## Product Change Notification / JAON-31VIRB105

**Notification Subject:**

CCB 6213 Final Notice: Qualification of MMT as a new final test site for selected SY84782xxx, SY88149xxx, SY88932xxx, SY88992xxx, SY89230xxx, SY89832xxx, SY89833xxx, SY89834xxx, SY89840xxx, SY89841xxx, SY89871xxx, SY89872xxx, SY89873xxx, SY89874xxx, SY89875xxx, SY89876xxx, and SYCUSTxxx device families available in 16L VQFN (3x3x1.00mm) package.

# Packing Information - Tape and Reel

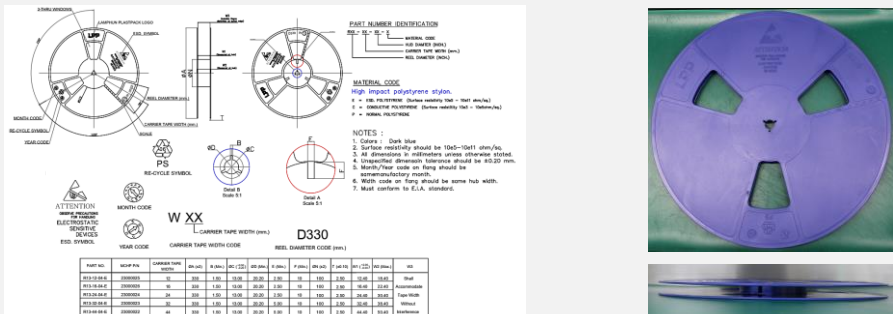
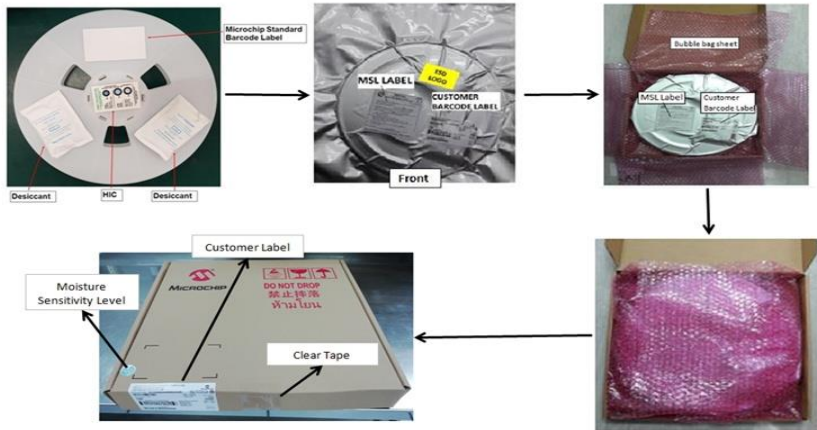
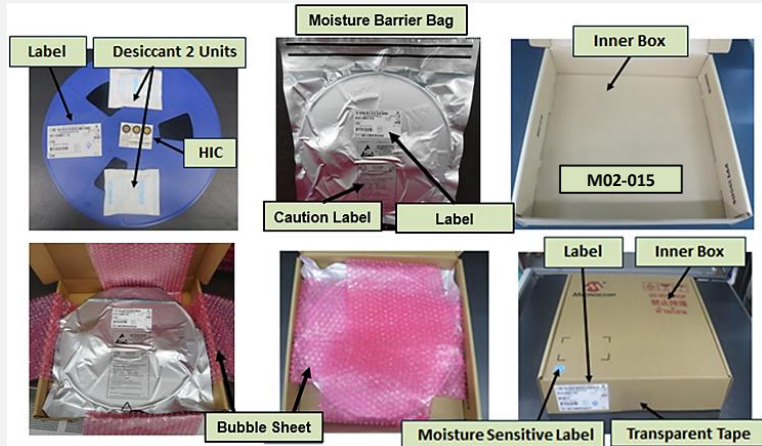
|                              | UNISEM (Pre)                                                                                                                                                                                                                               | MTAI (Post)                                                                                                                                                                                                                       |
|------------------------------|--------------------------------------------------------------------------------------------------------------------------------------------------------------------------------------------------------------------------------------------|-----------------------------------------------------------------------------------------------------------------------------------------------------------------------------------------------------------------------------------|
| Desiccant and HIC            | <div>  <div>2 X 1 unit Desiccant</div>  <div>3 Spot HIC</div> </div> | <div>  <div>Desiccant</div>  <div>HIC 3 dots</div> </div> |

# Packing Information - Tape and Reel

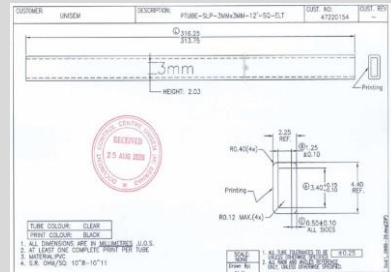
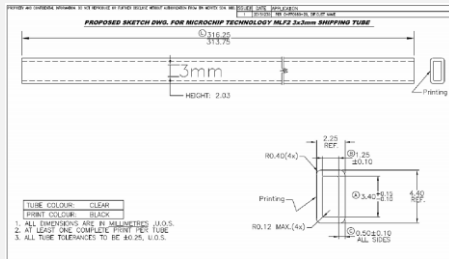
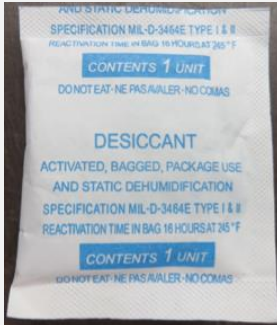
|                     | UNISEM (Pre)                                                                                                                                                                                                                                                                                                                                                                                                                                                                                                                                                                                                                                                                                                                                                                                                                                                                                                                                                                                     | MTAI (Post)                         |      |             |      |    |   |   |            |      |     |   |   |            |      |     |   |   |            |      |     |   |   |            |      |     |                                                                                                                                                                                                                                                                                                                                                                                                                                                                                                                                                                                                                                                                                                                                                                                                                                                                                                                                                                                                   |           |     |             |      |    |   |   |            |      |     |   |   |            |      |     |   |   |            |      |     |   |   |            |      |     |
|---------------------|--------------------------------------------------------------------------------------------------------------------------------------------------------------------------------------------------------------------------------------------------------------------------------------------------------------------------------------------------------------------------------------------------------------------------------------------------------------------------------------------------------------------------------------------------------------------------------------------------------------------------------------------------------------------------------------------------------------------------------------------------------------------------------------------------------------------------------------------------------------------------------------------------------------------------------------------------------------------------------------------------|-------------------------------------|------|-------------|------|----|---|---|------------|------|-----|---|---|------------|------|-----|---|---|------------|------|-----|---|---|------------|------|-----|---------------------------------------------------------------------------------------------------------------------------------------------------------------------------------------------------------------------------------------------------------------------------------------------------------------------------------------------------------------------------------------------------------------------------------------------------------------------------------------------------------------------------------------------------------------------------------------------------------------------------------------------------------------------------------------------------------------------------------------------------------------------------------------------------------------------------------------------------------------------------------------------------------------------------------------------------------------------------------------------------|-----------|-----|-------------|------|----|---|---|------------|------|-----|---|---|------------|------|-----|---|---|------------|------|-----|---|---|------------|------|-----|
| Carrier Tape        | <div><p>Section A-A</p><p>Notes:</p><ol style="list-style-type: none"><li>1. 10 sprocket hole pitch cumulative tolerance <math>\pm 0.2</math>.</li><li>2. Camber not to exceed 1mm in 100mm.</li><li>3. Material: PS + C.</li><li>4. <math>A_0</math> and <math>B_0</math> measured as indicated.</li><li>5. <math>K_0</math> measured from a plane on the inside bottom of the pocket to the top surface of the carrier.</li><li>6. Pocket position relative to sprocket hole measured as true position of pocket, not pocket hole.</li></ol><p>-All Dimensions in Millimeters-</p><table><tr><th>REVISIONS</th><th>NO.</th><th>DESCRIPTION</th><th>DATE</th><th>BY</th></tr><tr><td>1</td><td>1</td><td>ECO NUMBER</td><td>2006</td><td>2.0</td></tr><tr><td>2</td><td>2</td><td>ECO NUMBER</td><td>2006</td><td>2.0</td></tr><tr><td>3</td><td>3</td><td>ECO NUMBER</td><td>2006</td><td>2.0</td></tr><tr><td>4</td><td>4</td><td>ECO NUMBER</td><td>2006</td><td>2.0</td></tr></table></div> | REVISIONS                           | NO.  | DESCRIPTION | DATE | BY | 1 | 1 | ECO NUMBER | 2006 | 2.0 | 2 | 2 | ECO NUMBER | 2006 | 2.0 | 3 | 3 | ECO NUMBER | 2006 | 2.0 | 4 | 4 | ECO NUMBER | 2006 | 2.0 | <div><p>Section A-A</p><p>Notes:</p><ol style="list-style-type: none"><li>1. 10 sprocket hole pitch cumulative tolerance <math>\pm 0.2</math>.</li><li>2. Carrier not to exceed 1mm in 100mm.</li><li>3. Material: PS + C.</li><li>4. <math>A_0</math> and <math>B_0</math> measured as indicated.</li><li>5. <math>K_0</math> measured from a plane on the inside bottom of the pocket to the top surface of the carrier.</li><li>6. Pocket position relative to sprocket hole measured as true position of pocket, not pocket hole.</li></ol><p>-All Dimensions in Millimeters-</p><table><tr><th>REVISIONS</th><th>NO.</th><th>DESCRIPTION</th><th>DATE</th><th>BY</th></tr><tr><td>1</td><td>1</td><td>ECO NUMBER</td><td>2006</td><td>2.0</td></tr><tr><td>2</td><td>2</td><td>ECO NUMBER</td><td>2006</td><td>2.0</td></tr><tr><td>3</td><td>3</td><td>ECO NUMBER</td><td>2006</td><td>2.0</td></tr><tr><td>4</td><td>4</td><td>ECO NUMBER</td><td>2006</td><td>2.0</td></tr></table></div> | REVISIONS | NO. | DESCRIPTION | DATE | BY | 1 | 1 | ECO NUMBER | 2006 | 2.0 | 2 | 2 | ECO NUMBER | 2006 | 2.0 | 3 | 3 | ECO NUMBER | 2006 | 2.0 | 4 | 4 | ECO NUMBER | 2006 | 2.0 |
| Cover Tape          | <div><p>NOTE:</p><ol style="list-style-type: none"><li>1. REEL TO CONTAIN 300 METERS OF SPLICE FREE MATERIAL.</li><li>2. MATERIAL: ANTISTATIC POLYESTER FILM.</li><li>3. COLOR: TRANSPARENT, PALE BLUE.</li></ol><p>△ THESE WIDTHS ARE ALSO AVAILABLE IN 500 METER LENGTHS.</p><p>- All Dimensions in Millimeters -</p><table><tr><th>REVISIONS</th><th>NO.</th><th>DESCRIPTION</th><th>DATE</th><th>BY</th></tr><tr><td>1</td><td>1</td><td>ECO NUMBER</td><td>2006</td><td>2.0</td></tr><tr><td>2</td><td>2</td><td>ECO NUMBER</td><td>2006</td><td>2.0</td></tr><tr><td>3</td><td>3</td><td>ECO NUMBER</td><td>2006</td><td>2.0</td></tr><tr><td>4</td><td>4</td><td>ECO NUMBER</td><td>2006</td><td>2.0</td></tr></table></div>                                                                                                                                                                                                                                                              | REVISIONS                           | NO.  | DESCRIPTION | DATE | BY | 1 | 1 | ECO NUMBER | 2006 | 2.0 | 2 | 2 | ECO NUMBER | 2006 | 2.0 | 3 | 3 | ECO NUMBER | 2006 | 2.0 | 4 | 4 | ECO NUMBER | 2006 | 2.0 | <div><p>NOTE:</p><ol style="list-style-type: none"><li>1. REEL TO CONTAIN 300 METERS OF SPLICE FREE MATERIAL.</li><li>2. MATERIAL: ANTISTATIC POLYESTER FILM.</li><li>3. COLOR: TRANSPARENT, PALE BLUE.</li></ol><p>△ THESE WIDTHS ARE ALSO AVAILABLE IN 500 METER LENGTHS.</p><p>- All Dimensions in Millimeters -</p><table><tr><th>REVISIONS</th><th>NO.</th><th>DESCRIPTION</th><th>DATE</th><th>BY</th></tr><tr><td>1</td><td>1</td><td>ECO NUMBER</td><td>2006</td><td>2.0</td></tr><tr><td>2</td><td>2</td><td>ECO NUMBER</td><td>2006</td><td>2.0</td></tr><tr><td>3</td><td>3</td><td>ECO NUMBER</td><td>2006</td><td>2.0</td></tr><tr><td>4</td><td>4</td><td>ECO NUMBER</td><td>2006</td><td>2.0</td></tr></table></div>                                                                                                                                                                                                                                                               | REVISIONS | NO. | DESCRIPTION | DATE | BY | 1 | 1 | ECO NUMBER | 2006 | 2.0 | 2 | 2 | ECO NUMBER | 2006 | 2.0 | 3 | 3 | ECO NUMBER | 2006 | 2.0 | 4 | 4 | ECO NUMBER | 2006 | 2.0 |

# Packing Information - Tape and Reel

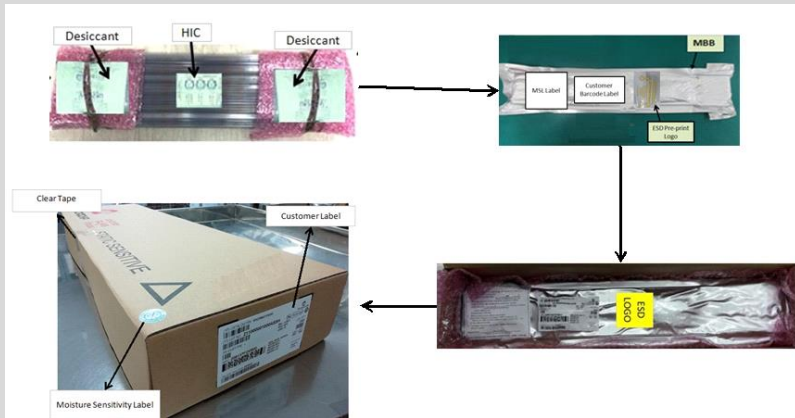
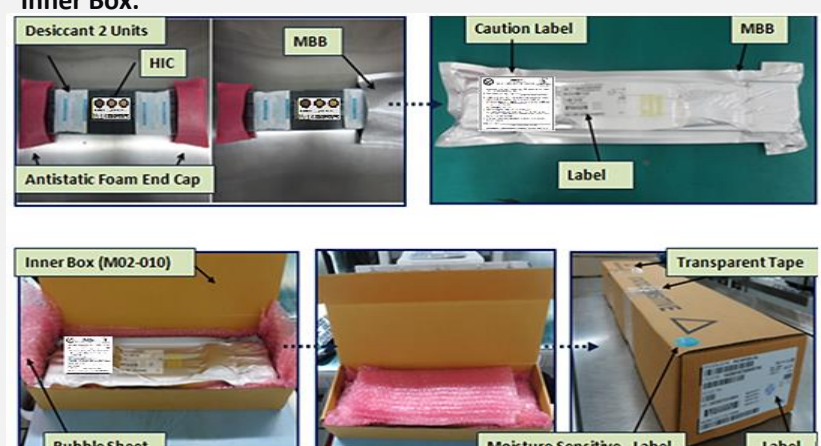
|                                                               | UNISEM (Pre)                                                                                   | MTAI (Post)                                                                                                                                                                                                                                                          |                |           |              |       |     |     |       |           |
|---------------------------------------------------------------|------------------------------------------------------------------------------------------------|----------------------------------------------------------------------------------------------------------------------------------------------------------------------------------------------------------------------------------------------------------------------|----------------|-----------|--------------|-------|-----|-----|-------|-----------|
| Final Test Location                                           | Unisem (M) Bhd                                                                                 | Microchip Technology Thailand (MMT)                                                                                                                                                                                                                                  |                |           |              |       |     |     |       |           |
| Packing Media                                                 | Tape & Reel                                                                                    | Tape and Reel                                                                                                                                                                                                                                                        |                |           |              |       |     |     |       |           |
| Reel                                                          | <div></div>  | <div></div> <table><tr><th>Diameter (mm.)</th><th>Hub (mm.)</th><th>W2 Max (mm.)</th><th>Color</th></tr><tr><td>330</td><td>100</td><td>18.40</td><td>Dark Blue</td></tr></table> | Diameter (mm.) | Hub (mm.) | W2 Max (mm.) | Color | 330 | 100 | 18.40 | Dark Blue |
| Diameter (mm.)                                                | Hub (mm.)                                                                                      | W2 Max (mm.)                                                                                                                                                                                                                                                         | Color          |           |              |       |     |     |       |           |
| 330                                                           | 100                                                                                            | 18.40                                                                                                                                                                                                                                                                | Dark Blue      |           |              |       |     |     |       |           |
| Antistatic Shielding Bag/Moisture Barrier Bag/Packing Process | <div></div> | <div><p>Inner Box:</p></div>                                                                                                                                                     |                |           |              |       |     |     |       |           |
